Title **Comments on Frame Structure for multi-hop relay**

Date Submitted **2007-01-08**

Re: Response to call for technical contributions regarding IEEE Project P802.16j.

Purpose Propose the text regarding frame structure design for multi-hop relay

Figure 2. Example of minimum configuration for an in-band non-transparent relay frame structure (Suggested as a replacement to Figure xyz in [1]).

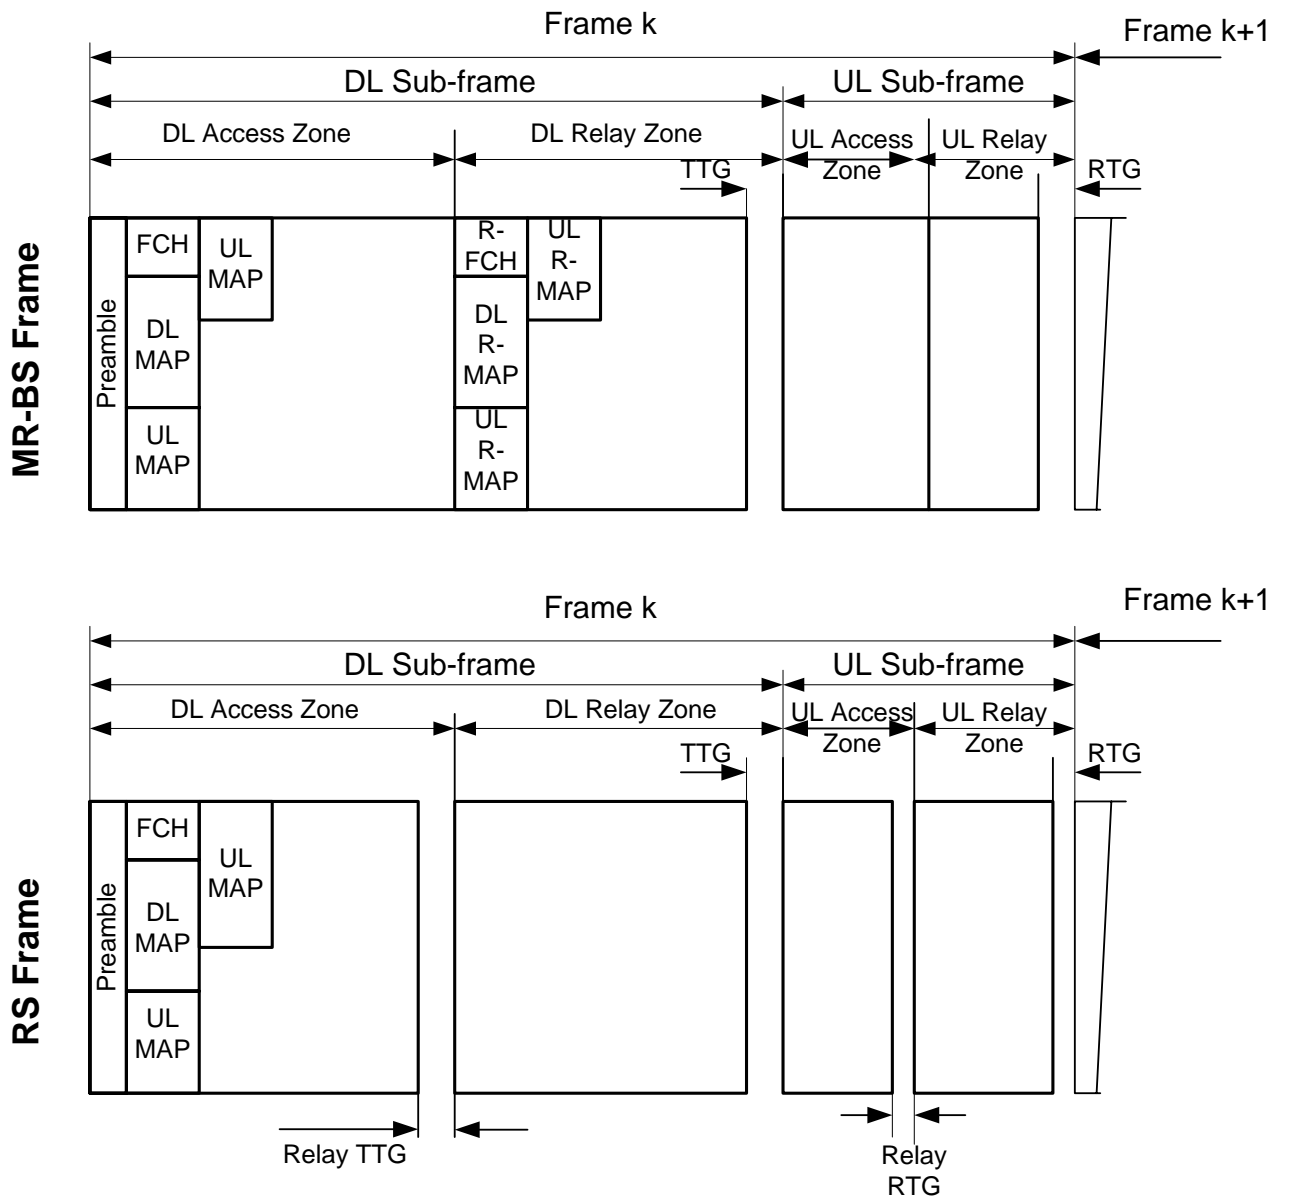
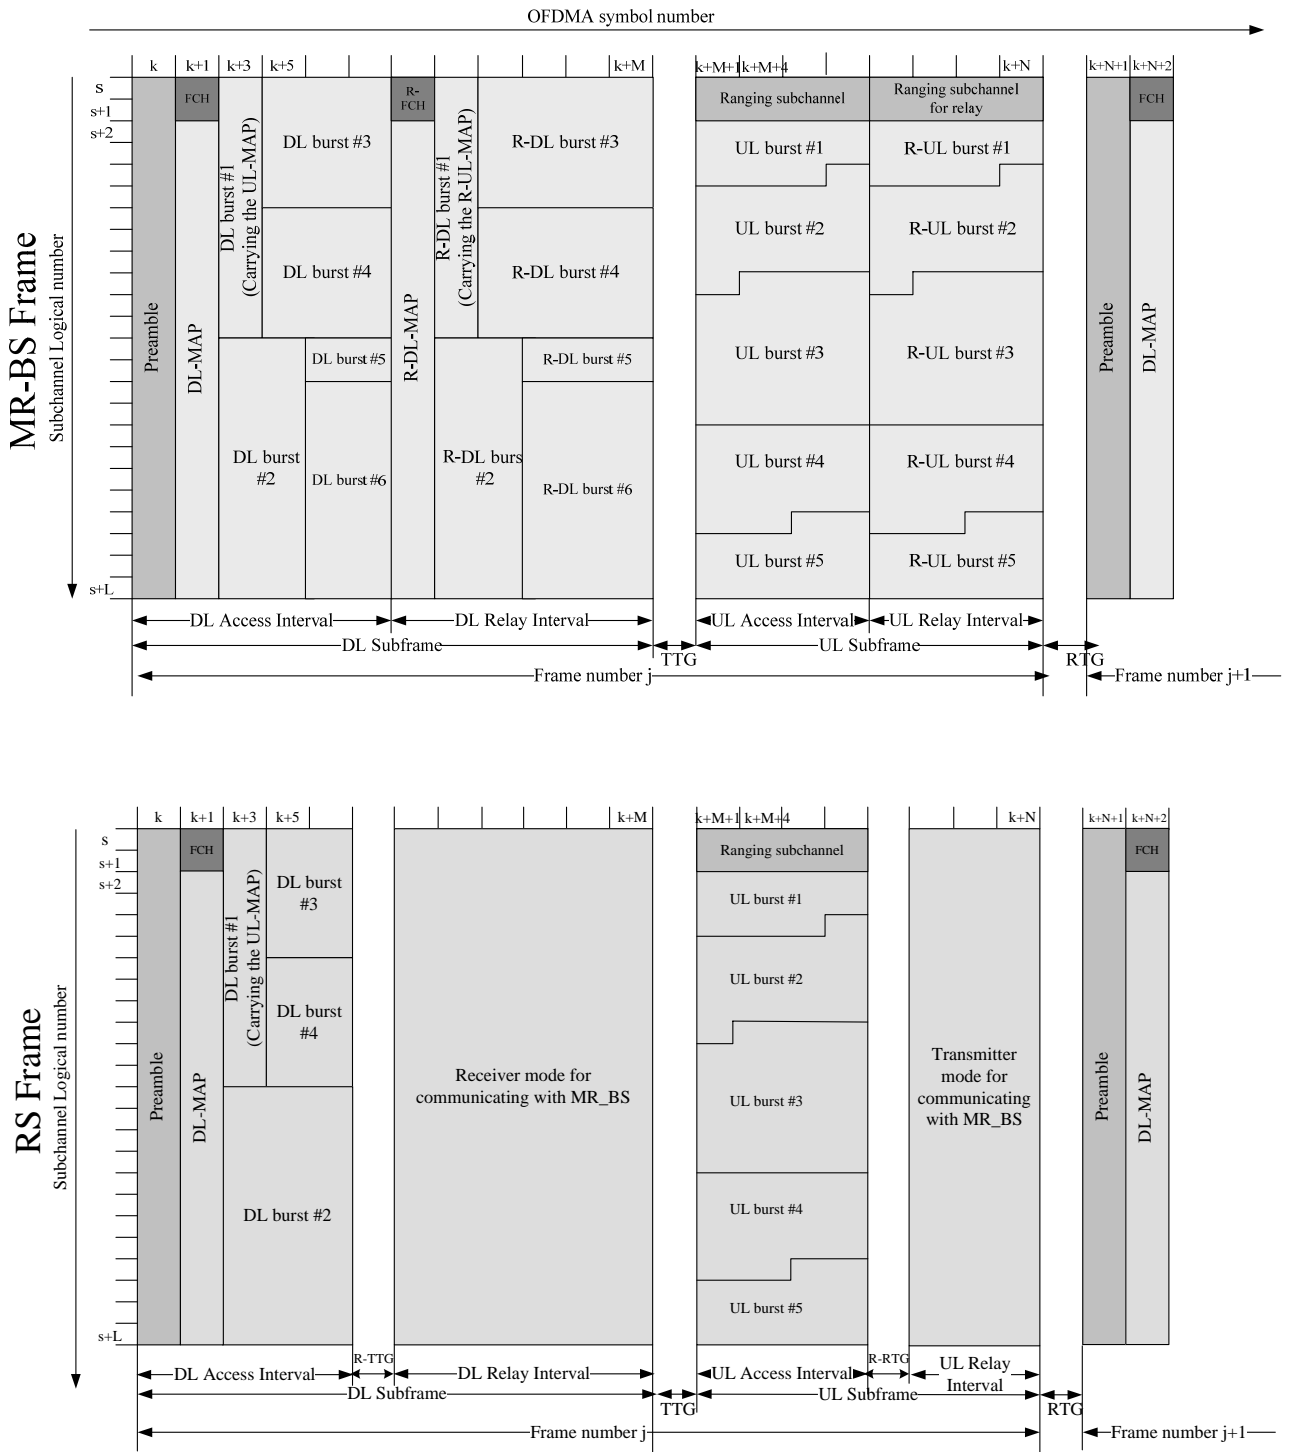
Figure 1 shows the minimum configuration of frame structure as agreed in the last meeting, i.e., a frame structure for two-hop relay. In this contribution Figure 2 is proposed with an aim to align Figure 1 such that it provides a similar level of detail as Figure 218 in the current specification .. In addition, it is argued that the term ‘zone’ used in the minimum configuration of frame structure may cause confusion when used together with the already existing terminology ‘zone’ as used in Figure 219, for instance. So, it is proposed that the term ‘zone’ as implied in [1] be replaced by the term ‘interval’ to avoid confusion.

Figure 3. Relay frame with multiple intervals

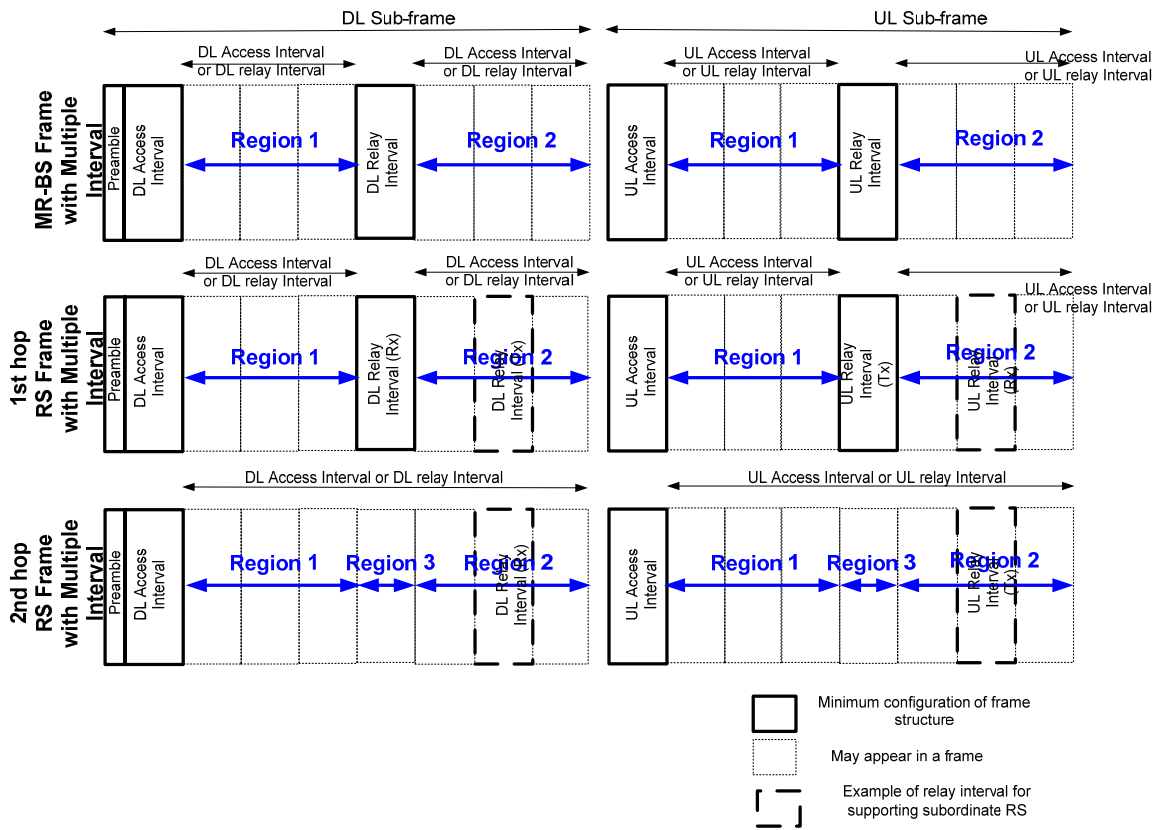
More importantly, to support multi-hop relay, the agreed minimum configuration of frame structure needs to be extended. Just as Figure 219 in the current specification [2] generalizes Figure 218, Figure 3 is provided as a generalization of Figure 2, to accommodate various frame configurations for supporting the multi-hop topology. According to the generalization illustrated in Figure 3, additional intervals to allow multi-hop capability may appear in a frame based on the minimum configuration of frame structure.

To be more specific, MR-BS frame and RS frame may have additional DL/UL access interval after the DL/UL relay interval to support its MSs. Alternatively, an RS frame may have additional DL/UL relay interval either before the DL/UL relay interval or after the DL/UL relay interval to support its subordinate RS. However, the number of additional interval may need to be limited for technical feasibility.

Note that the additional access intervals shall not include FCH and DL-MAP, while the additional relay interval may include R-FCH and R-DL-MAP.

Figure xxx Example of minimum configuration for an in-band non-transparent relay frame structure

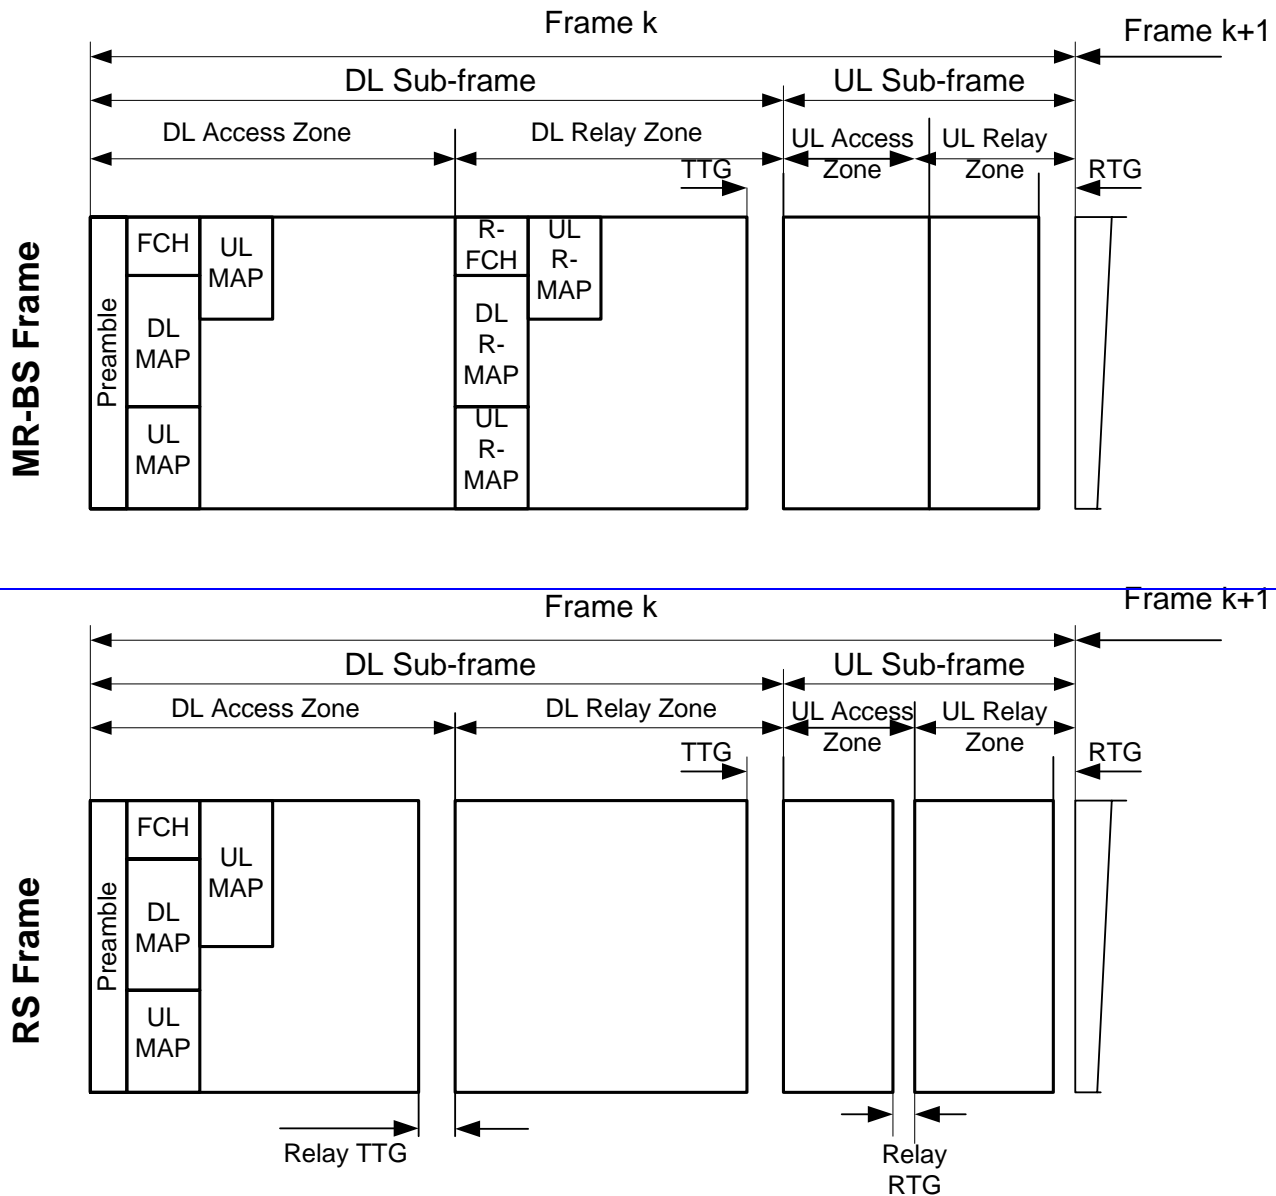
For the TDD mode, an example of the MR-BS frame structure is shown in Figure xxx.

Each MR-BS frame begins with a preamble followed by an FCH and the DL MAP and possibly UL MAP. The DL sub-frame shall include at least one DL Access ~~Zone~~ Interval and may include at least one or more DL Relay ~~Zone~~ Interval. The additional DL access-interval other than the first DL access interval shall begin with burst. The UL sub-frame may include at least one or more UL Access ~~Zone~~ Interval and it may include at least one or more UL Relay ~~Zone~~ Interval. In each frame, the TTG shall be inserted between the DL sub-frame and the UL sub-frame. The RTG shall be inserted at the end of each frame. In the DL Access ~~Zone~~ Interval, the subchannel allocation, the FCH transmission, and the FCH shall be defined as in Section 8.4.4.2.

The DL Relay ~~Zone~~ Interval shall include a R-FCH and a R-MAP. In the DL Relay ~~Zone~~ Interval, the subchannel allocation may be the same as that in the DL Access ~~Zone~~ Interval. The R-FCH may be the same as the FCH in the DL Access ~~Zone~~ Interval. Other attributes of the MR-BS frame and the RS frame such as transition between modulation and coding, presence of multiple Intervals, may be the same as those described in 8.4.4.2.

The number, size, and location of the relay zones shall be configurable.

Figure yyy Relay frame with multiple intervals

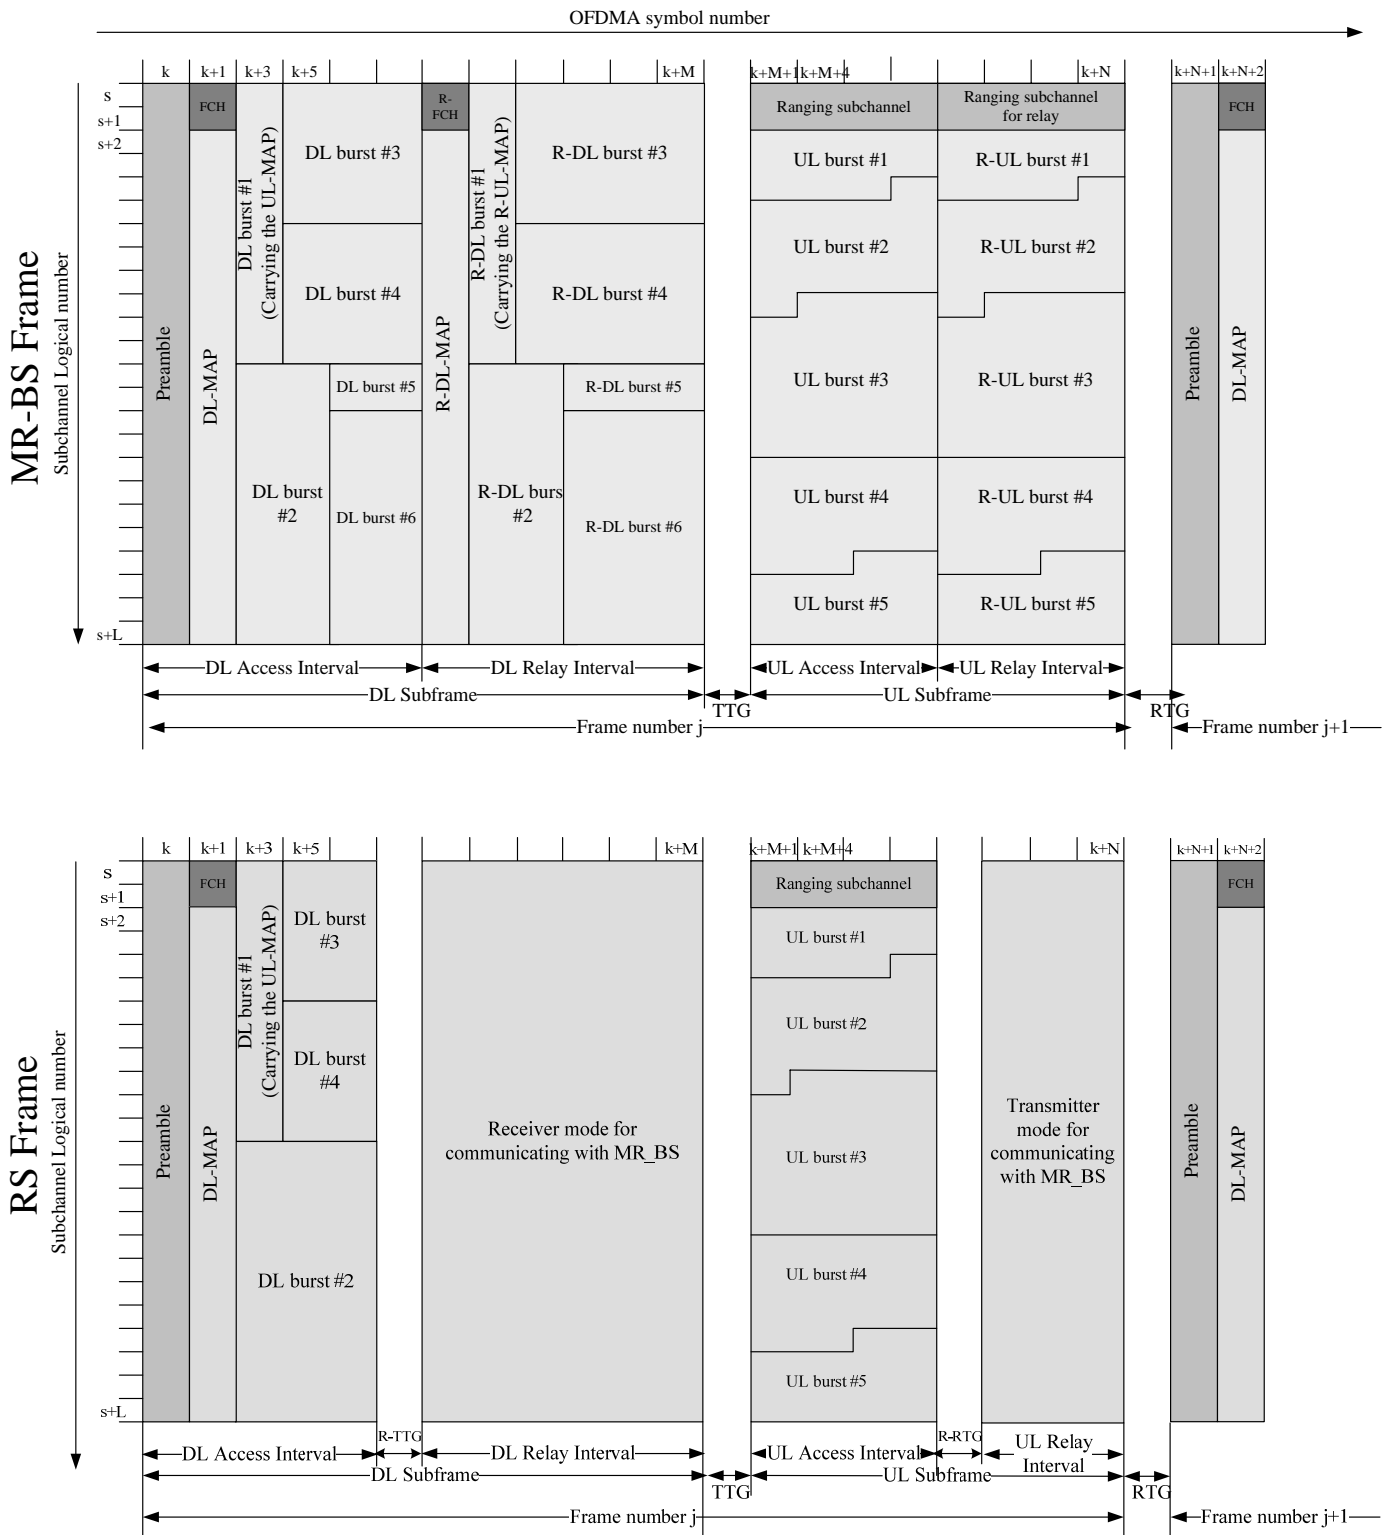
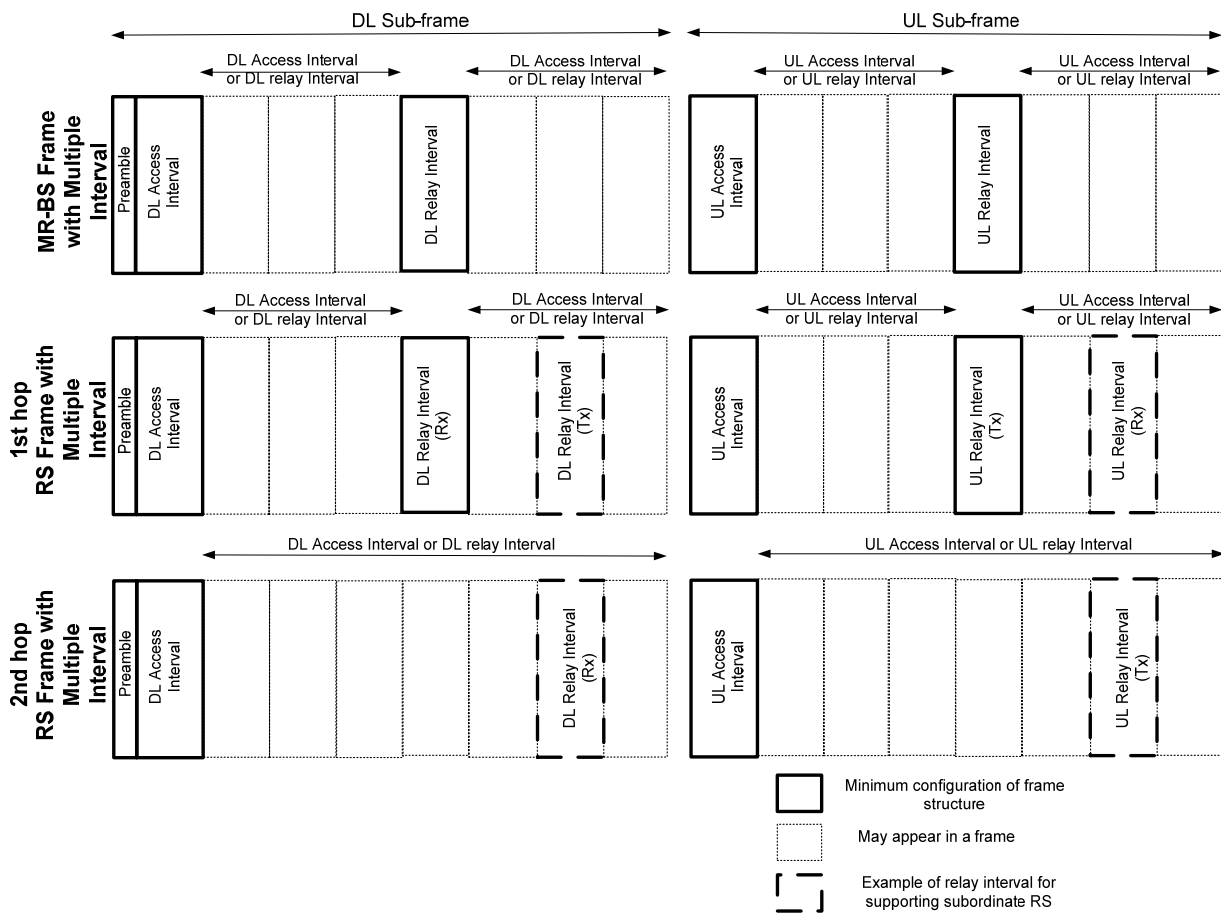
For the TDD mode, an example of an RS frame structure is shown in Figure xxx.

The DL sub-frame shall include at least one DL Access Zone Interval and may include at least one or more DL Relay Zone Interval. The additional DL access interval may be placed after the relay interval. The additional DL access Interval other than the first DL access Interval shall begin with burst. The additional DL relay interval

may be placed either before the relay interval or after the relay interval to communicate with its subordinated Relay station. An R-TTG may be placed between a DL Access ~~Zone~~ Interval and a DL Relay ~~Zone~~ Interval. The UL sub-frame may include at least one or more UL Access ~~Zone~~ Interval and at least one or more UL Relay ~~Zone~~ Interval. An R-RTG may be placed between a UL Access ~~Zone~~ Interval and a UL Relay ~~Zone~~ Interval.

If the relay station switches from transmission to reception mode, an R-TTG shall be required. If the relay station switches from reception to transmission mode, an R-RTG shall be required. There may be more than one R-TTG and more than one R-RTG inserted in the RS frame. In each frame, the TTG shall be inserted between the DL sub-frame and the UL sub-frame. The RTG shall be inserted at the end of each frame.

The contents of the FCH, DL MAP, and UL MAP in the Relay Frame may be different from those in the MR-BS Frame.

Each RS frame begins with a preamble followed by an FCH and the DL MAP and possibly a UL MAP. In the DL Access ~~Zone~~ interval, the subchannel allocation, the FCH transmission, and the FCH shall be as defined in Section 8.4.4.2. The content of the number, size, and location of the relay intervals shall be configurable.

Figure yyy depicts the BS frame and the RS frame with multiple intervals.
